Response to Comments

**AV Apollo Solar Project
Sunbow Solar I LLC, Syracuse Solar LLC, and Tours Solar LLC**

**CUP 37, Map 214
CUP 38, Map 214
CUP 39, Map 214
CUP 41, Map 214
GPA 5, Map 214**

**Kern County
Planning and Natural Resources Department
Bakersfield, California**

Chapter 3, Project Description, Page 3-12:

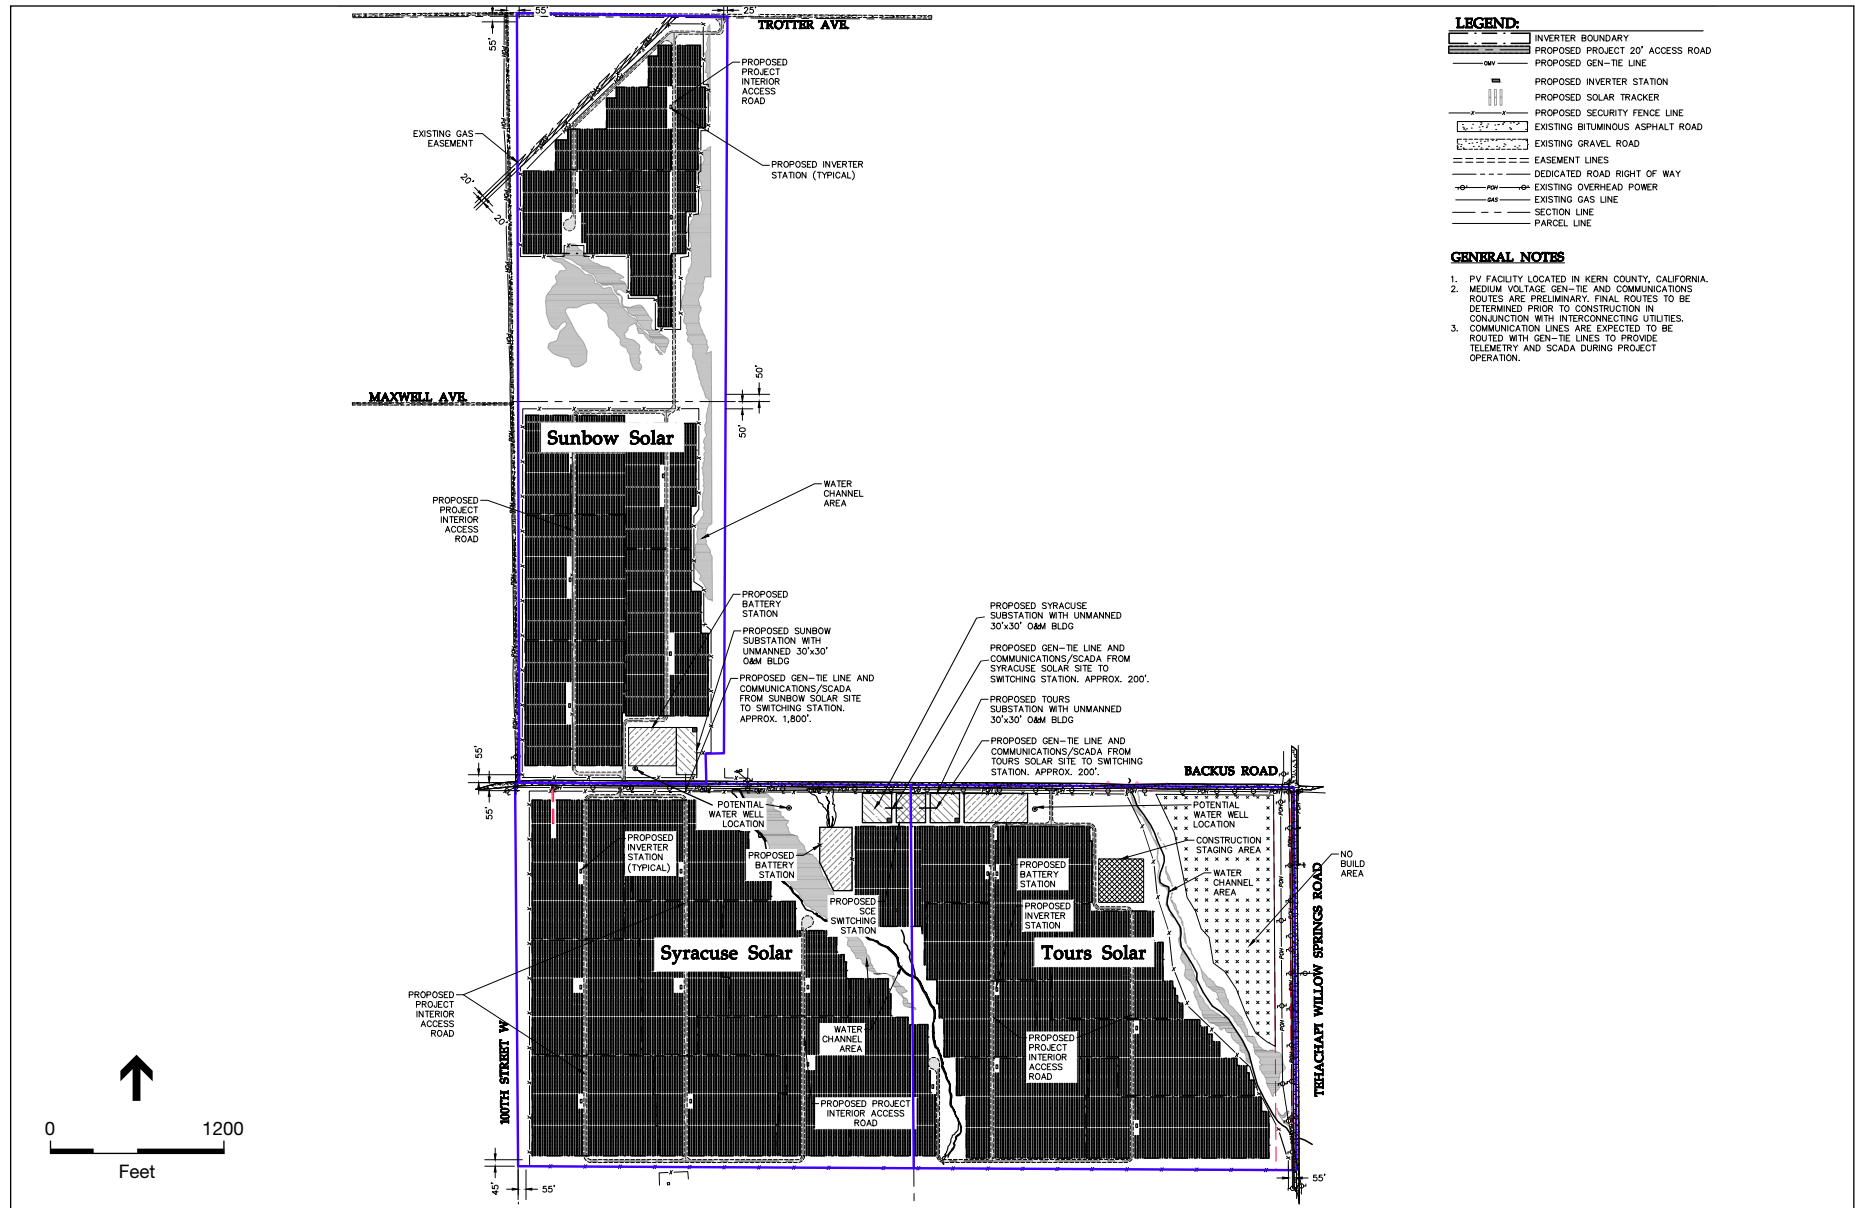
Figure 3-6, *Overall Site Plan*, in Chapter 3, *Project Description*, of the Draft EIR, has been updated to show the revised eastern fence boundary.

Appendix E, Biological Analysis Report, Figure 15, Critical Habitat and Movement Corridors and Linkages:

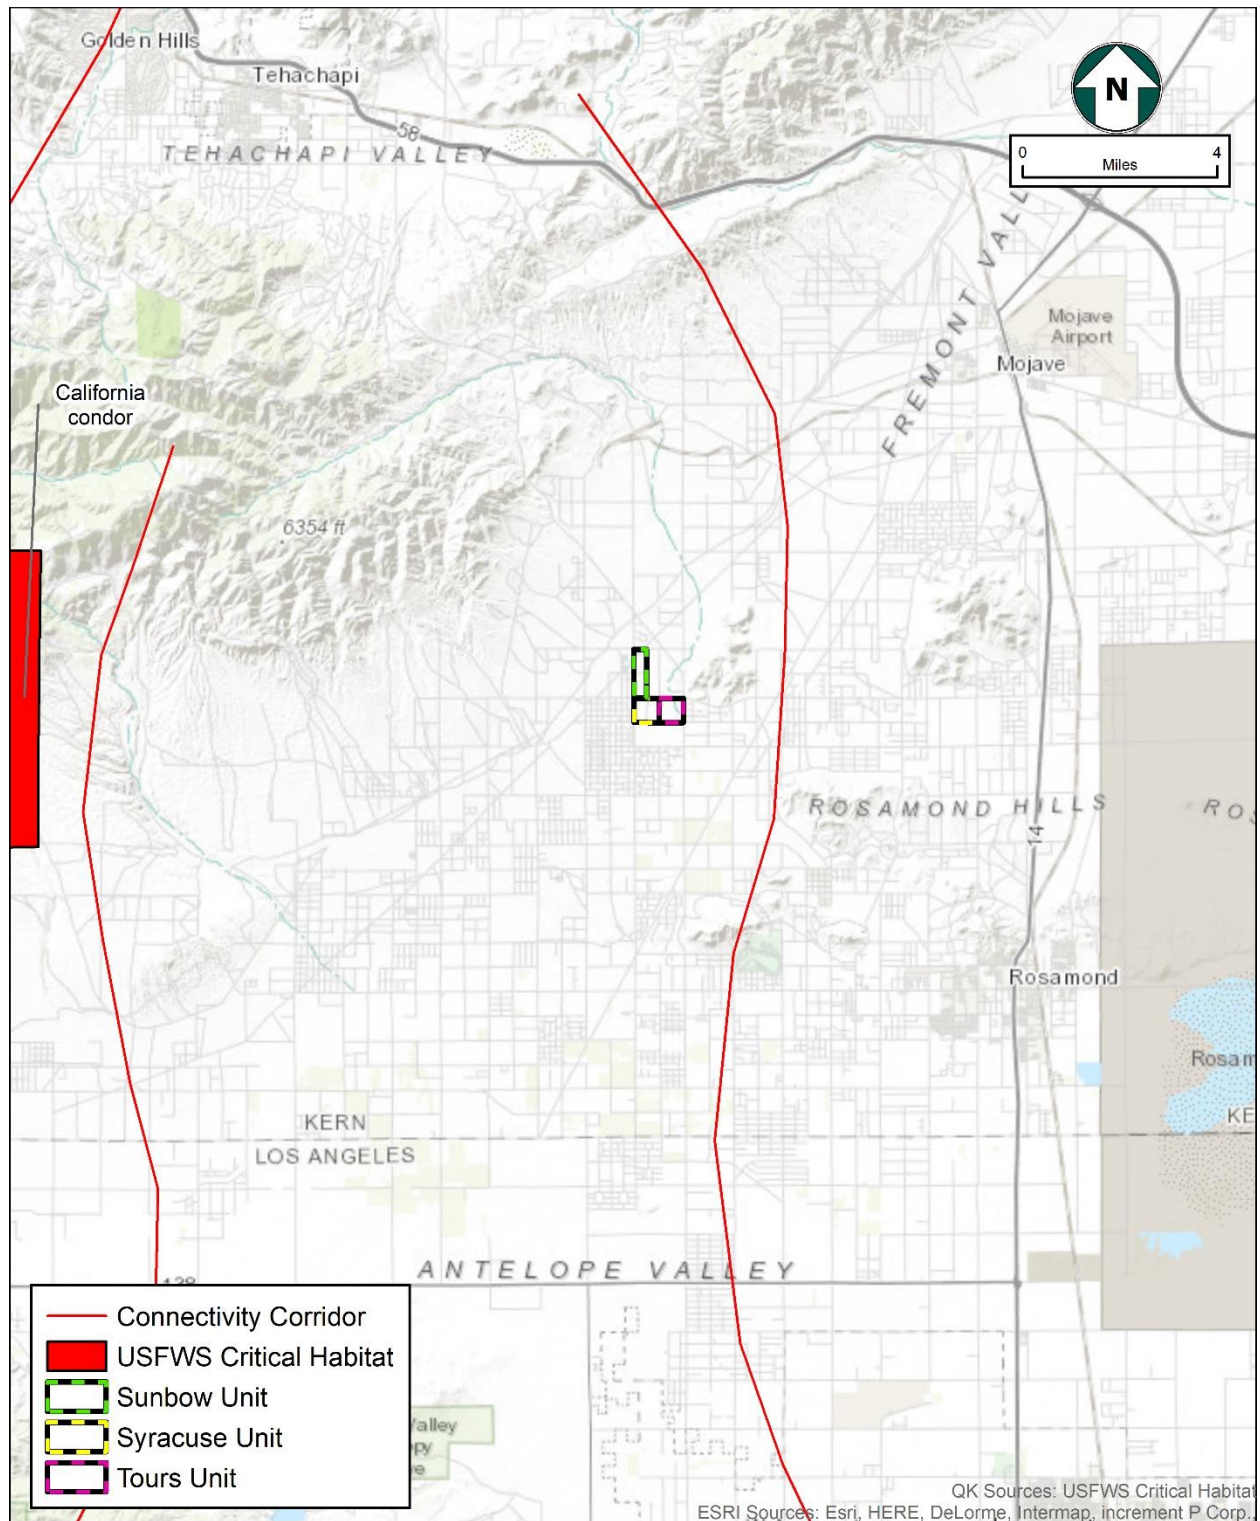
Figure 15, *Critical Habitat and Movement Corridors and Linkages*, of Appendix E, of the Draft EIR, has been updated to show the project's relationship to existing wildlife corridors.

The Map below shows the project site:

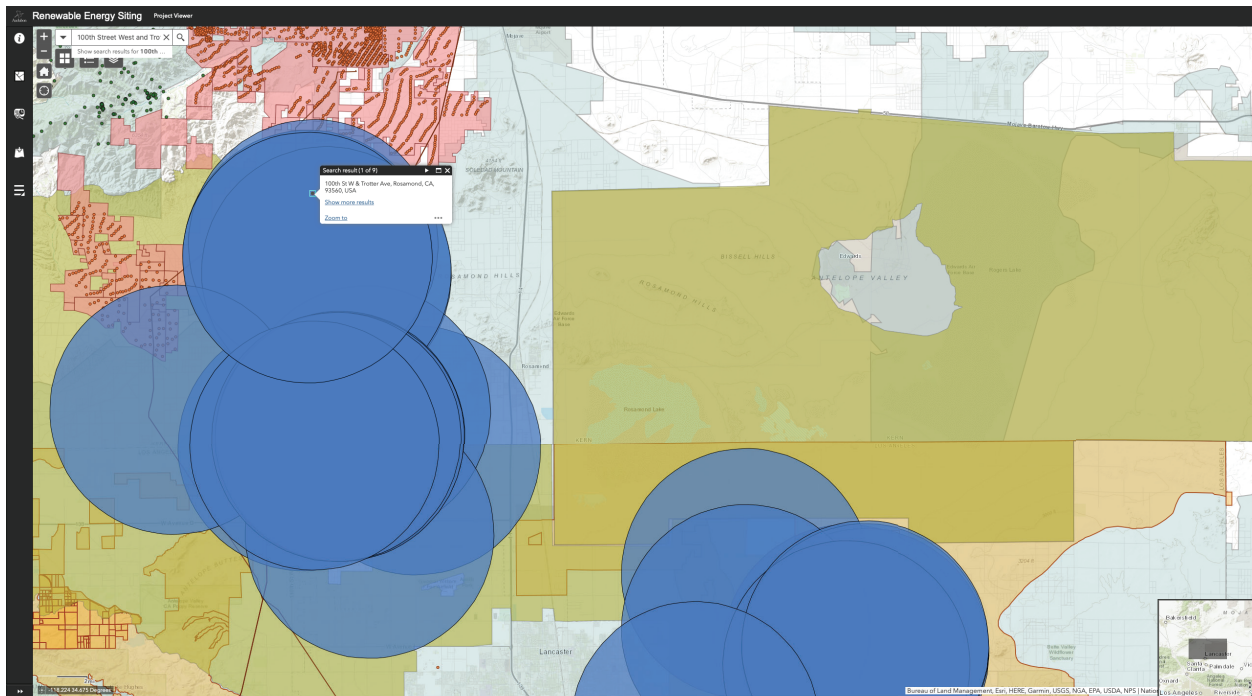
This Map was made from publicly available spatial data on SWHA nests from CDFW, 2017 which shows 5-mile radius in blue around 3 Swainson's hawk nests that are recorded as active – one in 2015 and two in 2016 – within 5 miles of the project site, which is marked.

Figure 1

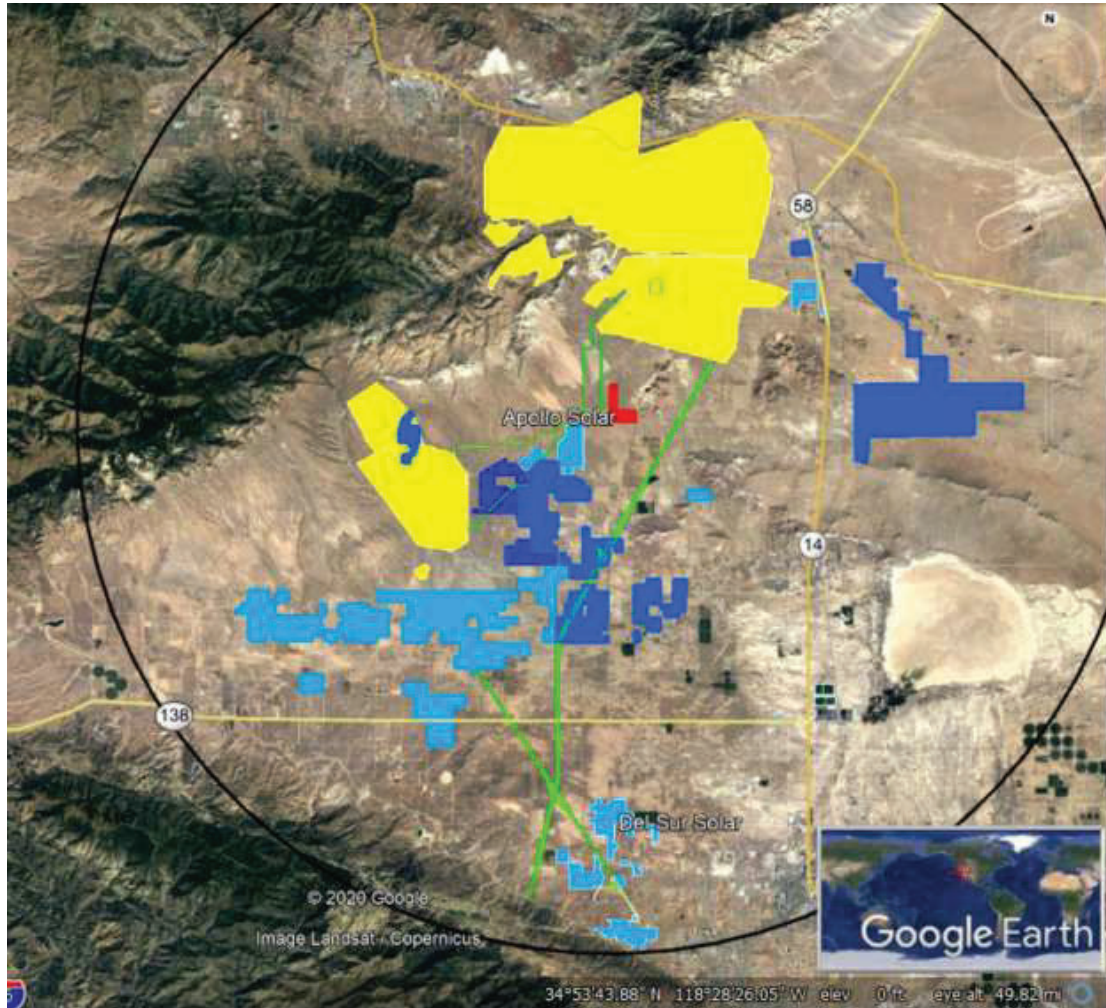
¹⁵⁴ Owens Comments, p. 24; p. 59, Figure 1 – Cumulative Impacts: Existing Renewable Energy Projects Within a 20-mile radius.

Figure 2

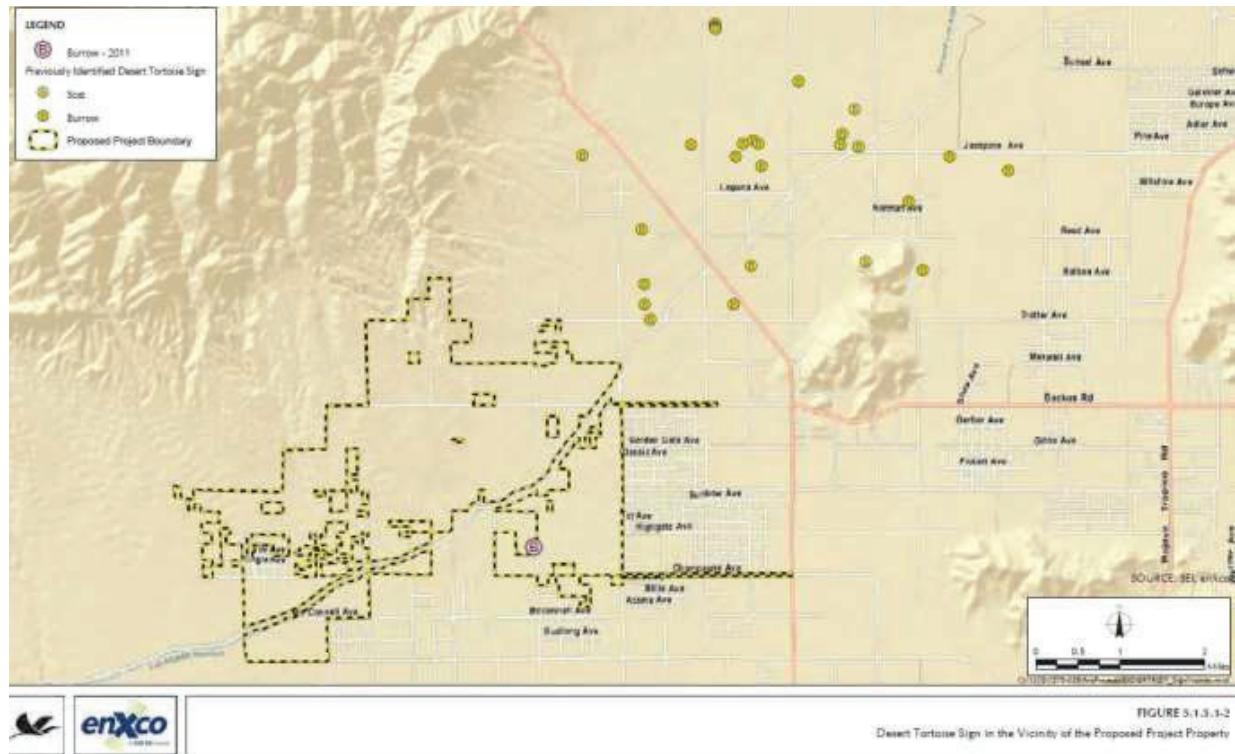
the DT to be “assumed present.”¹²³ The DEIR also mapped both DT burrows (Figure 2) and DT detections (Figure 3). As the maps illustrate, a DT was observed one mile west of this Project. DT burrows were detected within 0.1 mile of the Project, and another 4 detected between 0.5 and 1 mile of the Project. As summarized by the CREP report, “Additional indications of desert tortoise, specifically 24 burrows and 4 scat, were discovered between 0.6 and 5.1 miles northeast of the project boundary, and two live desert tortoises were observed 4.3 miles to the northeast,” where the Project is located. As such, one can conclude that contrary to the DEIR’s conclusions, this site has a high potential for DT to occur. This is reinforced by the USGS map of predicted occupied habitat (“distribution”) for the DT on and bordering the Project site (Figure 5).

Figure 4
Projected Joshua Tree Loss (USFWS 2018)

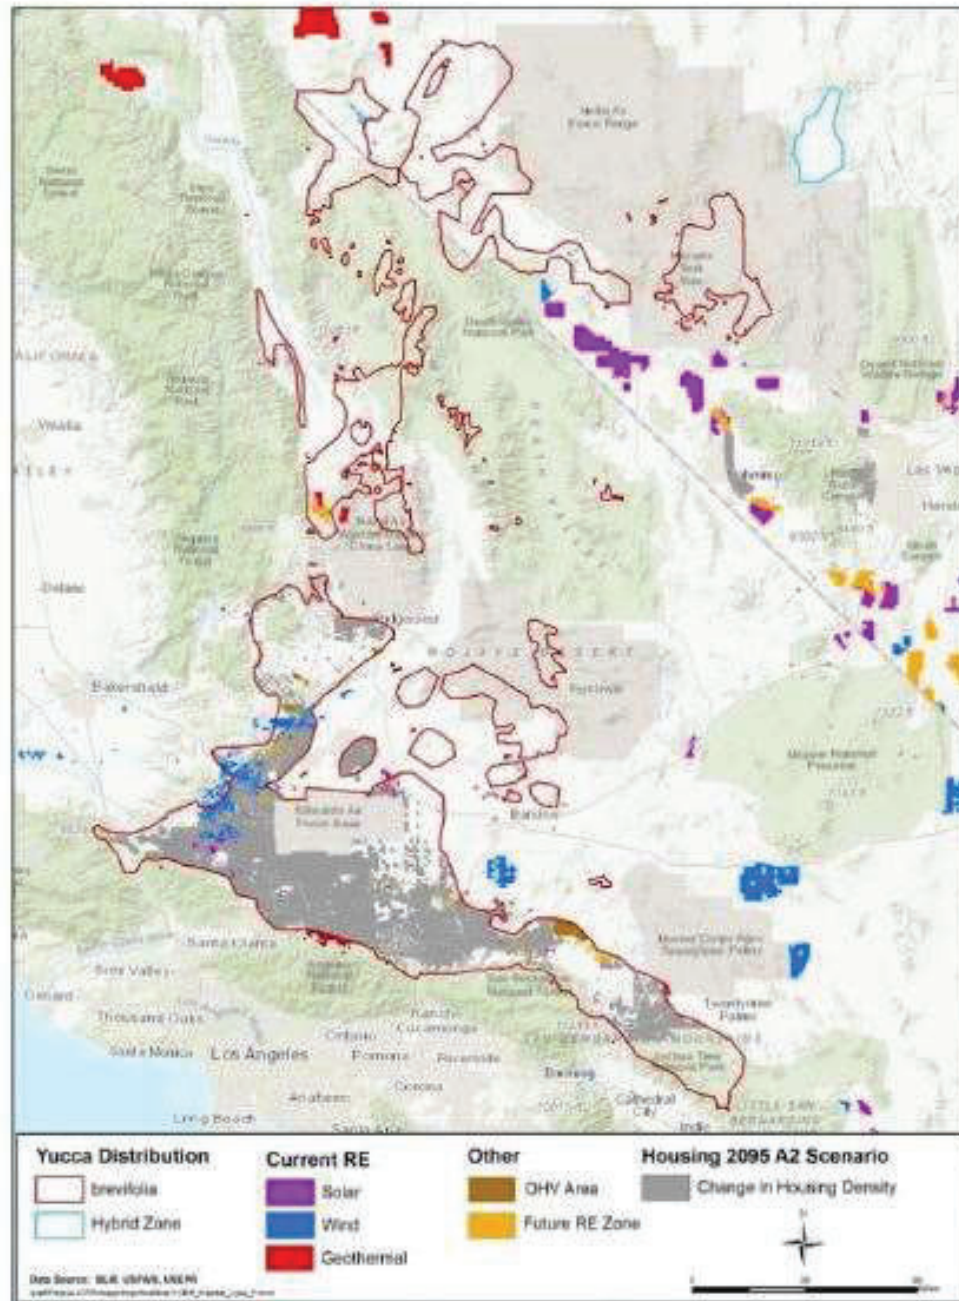
streamlined review process to facilitate renewable energy development, approximately 50,000 acres fall within the mapped distribution for *Y. brevifolia* (USFWS 2018).¹⁵⁷ According to the USFWS, “Contributors to large-scale habitat loss across the range of *Y. brevifolia* may include urban expansion and development, military installation expansion and training activities, **renewable energy development**, grazing, and off-highway vehicle (OHV) use (emphasis added).”¹⁵⁸ Figure 4 shows the USFWS 2018 Joshua tree projected habitat loss due to a combination of urban growth and large-scale energy projects. Based on this prediction, the Antelope Valley could lose the vast majority of its Joshua tree habitat due to residential and industrial development.

Figure 6

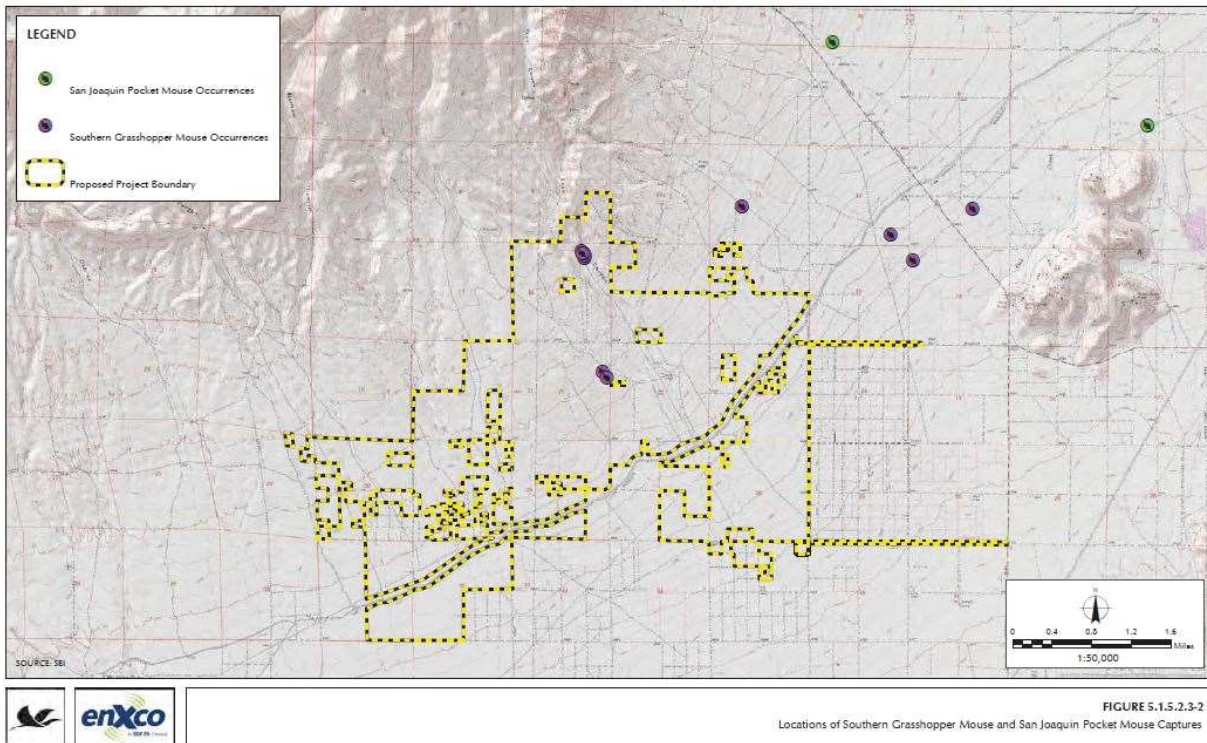
9. San Joaquin pocket mouse (*Perognathus inornatus*) BLM
No focused surveys were conducted for this species for which onsite habitat exists, therefore to consider it absent is scientifically unsupported. This species was detected near this Project site in the Catalina Renewable Energy Project DEIR surveys (Figure 6).

This species is not mentioned at all in the DEIR and yet habitat exists onsite. This species was detected near this Project site in the Catalina Renewable Energy DEIR surveys (Figure 6).

Figure 7

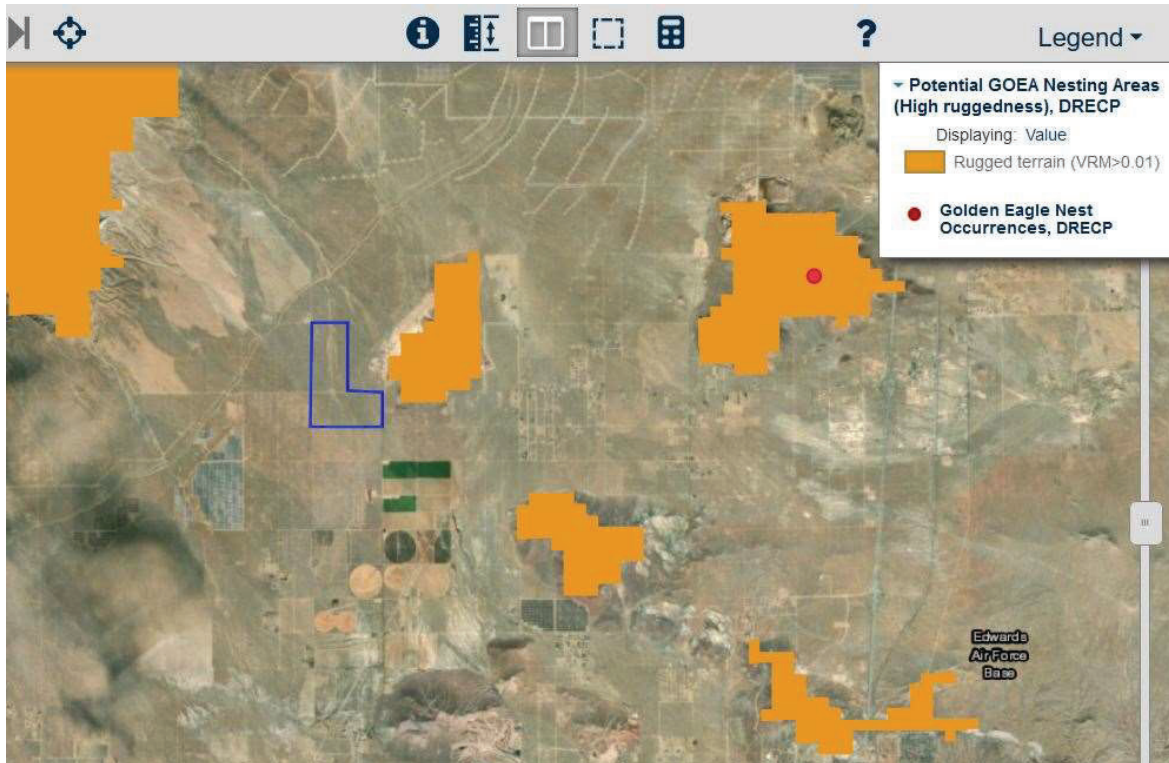
In fact, eagle research for the DRECP by USGS shows a golden eagle nest was observed 6.4 miles from the Project, and identifies potential nesting habitat less than a half mile away (Figure 7). eBird observations from 2016 show four sightings of golden eagles 1.2 miles from the nearby USGS reported nest site, 5.2 miles east of the Project.⁷¹ Even a cursory glance at eagle movements (e.g. USGS biotelemetry data for nesting eagles in southern California)⁷² around nest sites reveal they repeatedly fly many miles (i.e. up to and beyond 30 miles from a nest site) to forage, necessitating impact analysis far beyond whether or not eagles are observed during a non-focused site assessment, as presented by the DEIR.

Figure 4: Size of cocci spores compared to soil particles (in mm)
(from: Fisher et al., 2007, Fig. 3)

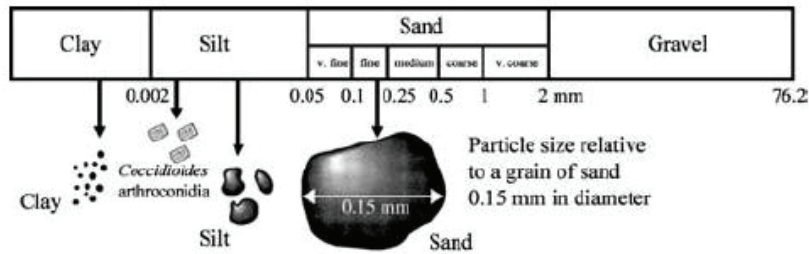
Valley Fever spores have been documented to travel as much as 500 miles⁴¹ and dust raised during construction could potentially expose a large number of people located miles away.
